**CERTIFICATE OF APPROPRIATENESS****Application Date:** October 29, 2014**Applicant:** Robert Garner, Owner**Property:** 521 Euclid Street, Lot 1, Tracts 11 and 12A, Block 22, Woodland Heights Subdivision. The property includes a historic 1,222 square foot one-story wood frame single-family residence and a detached garage situated on a 5,000 square foot (50' x 100') interior lot.**Significance:** Contributing Craftsman style residence, constructed circa 1920, located in the Woodland Heights Historic District**Proposal:** Alteration – Construct a two story 1,711 square foot addition to the rear of a contributing one story 1,222 square foot residence.

**Recommendation:** Denial - does not satisfy criteria

**SOUTH ELEVATION – FRONT FACING EUCLID STREET**

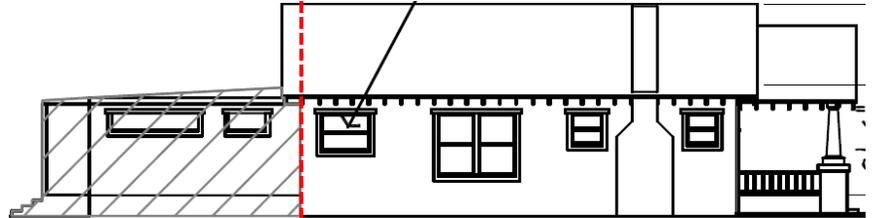
The applicant revised their application to include the first two changes but did not move the east side portion of the addition back. The resulting visually prominent side addition amplifies the size of the addition as a whole and creates an appearance that is out of scale with the existing home and other contributing homes within the Woodland Heights Historic District.

**Staff also finds that the proposed addition would likely conform to all 11 criteria if the east side portion of the addition were moved back 7' away from the front property line. This would reduce the visibility of the addition and create an appearance similar to that of a residence with a rear two story garage apartment when viewed from the street.**

**EAST SIDE ELEVATION**

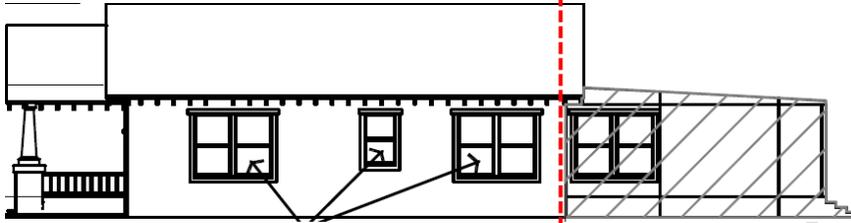
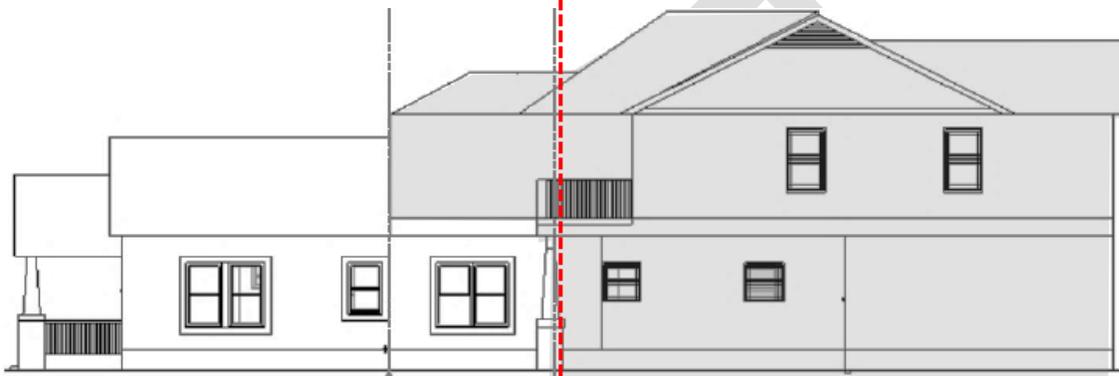
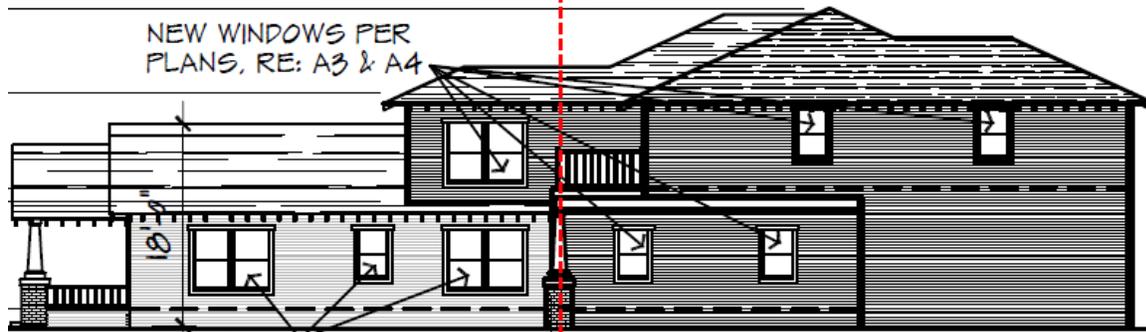
- (8) Proposed additions or alterations must be done in a manner that, if removed in the future, would leave unimpaired the essential form and integrity of the building, structure, object or site;  
*The second floor of the proposed addition will encroach on the rear 13' of the original home. This jeopardizes the essential form and integrity of the historic structure because the existing building fabric underneath this encroachment must be removed or irreparably altered in order to support the added weight of the new second floor.*

- (9) The proposed design for any exterior alterations or addition must not destroy significant historical, architectural or cultural material and must be compatible with the size, scale, material and character of the property and the area in which it is located;  
*The encroachment of the addition on the existing house a destruction of significant historical architectural material. In addition, the addition's relatively large size and complicated massing are not of compatible scale with the existing house and the Woodland Heights Historic District.*
